Technical Service Bulletin

NUMBER: 24-17-99

Vibration Or Noise From HVAC Blower Motor

2000 (PL) Neon

FIGURE 1

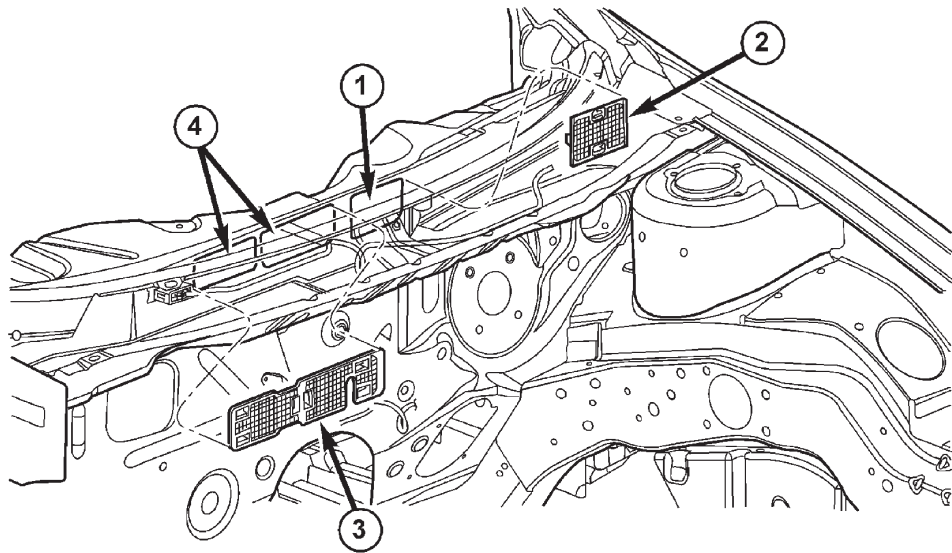
1. Remove the HVAC blower motor following the procedure in the 2000 Neon Service Manual (Publication No. 81-270-0025) beginning on page 24-21.
2. Remove any debris which is found in the HVAC blower motor.
3. Remove both wiper arm assemblies following the procedure in the 2000 Neon Service Manual (Publication No. 81-270-0025) beginning on page 8K-5.
4. Remove the cowl plenum to hood weatherstrip (Figure 1).
5. Remove the left and right fender to hood hinge seals (Figure 1).
6. Remove the cowl top screen assembly following the procedure in the 2000 Neon Service Manual (Publication No. 81-270-0025) beginning on page 23-27.
7. Remove any debris found in the cowl plenum.
8. Install the HVAC blower motor following the procedure in the 2000 Neon Service Manual (Publication No. 81-270-0025) beginning on page 24-21.
9. Operate the HVAC blower motor to verify that all debris has been removed.

1-	FENDER TO HOOD HINGE SEAL
2-	FENDER TO HOOD HINGE SEAL
3-	COWL PLENUM TO HOOD WEATHERSTRIP

- 10. Install the new cowl plenum screens into the holes in the cowl plenum reinforcement as shown in Figure 2.
- 11. Install the cowl top screen assembly.
- 12. Install the new fender to hood hinge seals.
- 13. Install the cowl plenum to hood weatherstrip.
- 14. Install the wiper arm assemblies.
